SUBJECT: AMENDMENT NO. 76 TO FACILITY OPERATING LICENSE NO. NPF-3;

The Commission has issued Amendment No. 76 to Facility Operating License No. NPF-3 for the Davis-Besse Nuclear Power Station, Unit No. 1. This amendment modifies the Appendix A Technical Specifications in response to Item 5 of your application dated December 26, 1980 (No. 669) and as revised by Item 5 of your letter dated July 10, 1981 (No. 731) and your letter dated July 8, 1983 (No. 966).

DAVIS-BESSE NUCLEAR POWER STATION, UNIT NO. 1

ATTACHMENT TO LICENSE AMENDMENT NO. 76

Figure 6.2-2

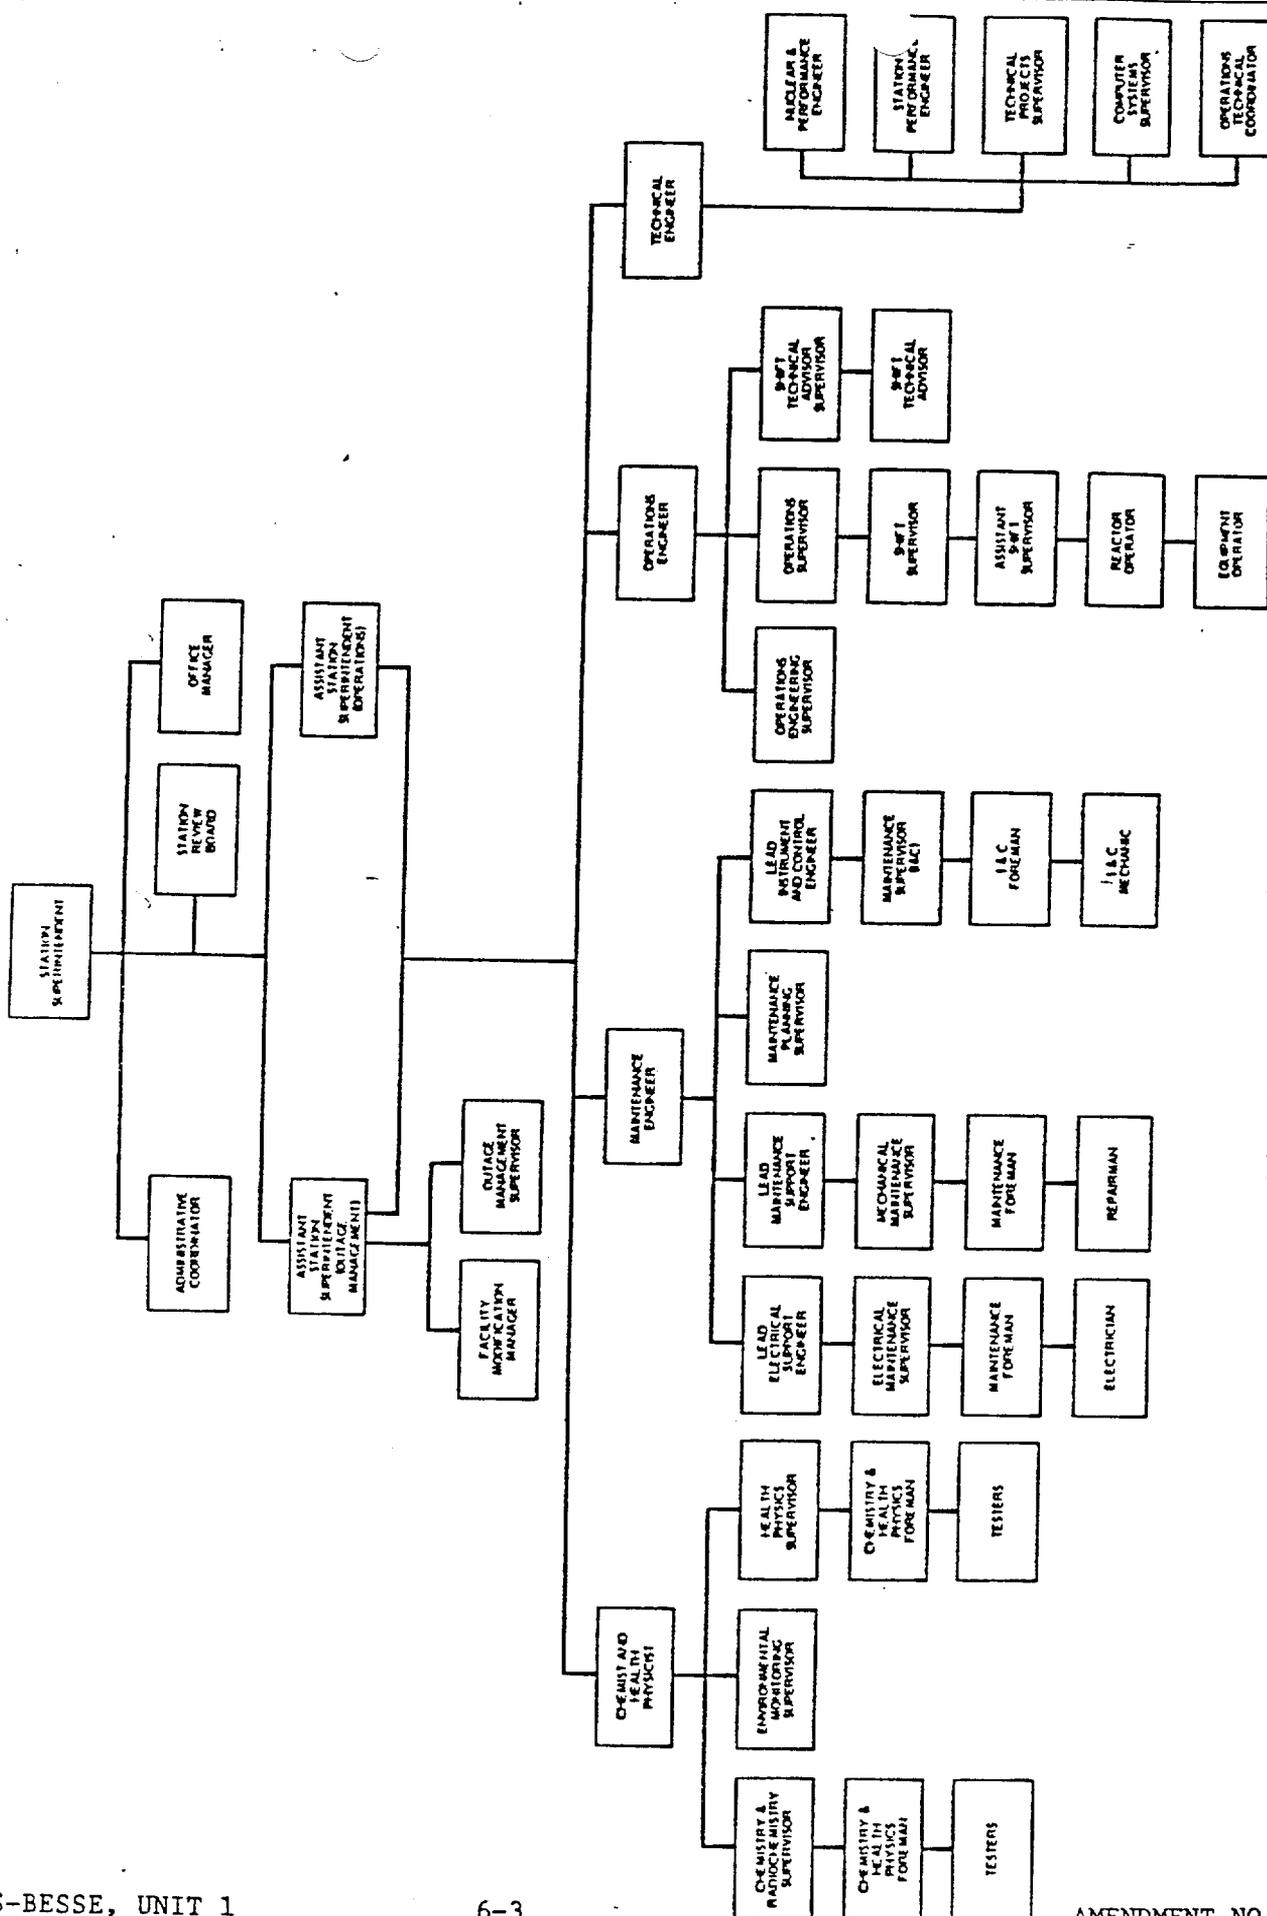
This amendment modifies Figures 6.2-1 and 6.2-2 to reflect the current organizational structure applicable to the Davis Besse Nuclear Power Station and Sections 6.5.1.2 and 6.5.2.2 to specify the composition of the Station and Company Nuclear Review Boards respectively.

By letters dated December 26, 1980 (Item 5) and July 10, 1981, which were superseded by letter of July 8, 1983, Toledo Edison Company (the licensee) made application to amend Facility Operating License No. NPF-3 for the Davis-Besse Nuclear Power Station, Unit No. 1, to reflect changes that were made in names and titles of both the Company Nuclear Review Board (CNRB) and the Station Review Board (SRB) membership requirements, the relocation of some groups from the site organization to the corporate organization, and the deletion of licensed designations from positions in the SRB.

The staff has reviewed the proposed changes and find that management control and lines of authority and communication have not been weakened by the proposed changes in the off-site or on-site structures and the QA organization has retained the safe independence and authority as is in the current Technical Specifications. We find that the station superintendent authority has not been weakened or diffused by the proposed on-site structure changes. The deletion of the operator license designations from positions in the on-site operating organization from Figure 6.6-2 does not relieve the licensee from these requirements of ANSI N18.1-1971, Selection and Training of Nuclear Power Plant Personnel for operations Management (Section 4.4.2), Intermediate and First Line Supervisors (Section 4.3.1) and Operators (Section 5.4.1). Based on the staff's review, the proposed Technical Specification changes are acceptable.
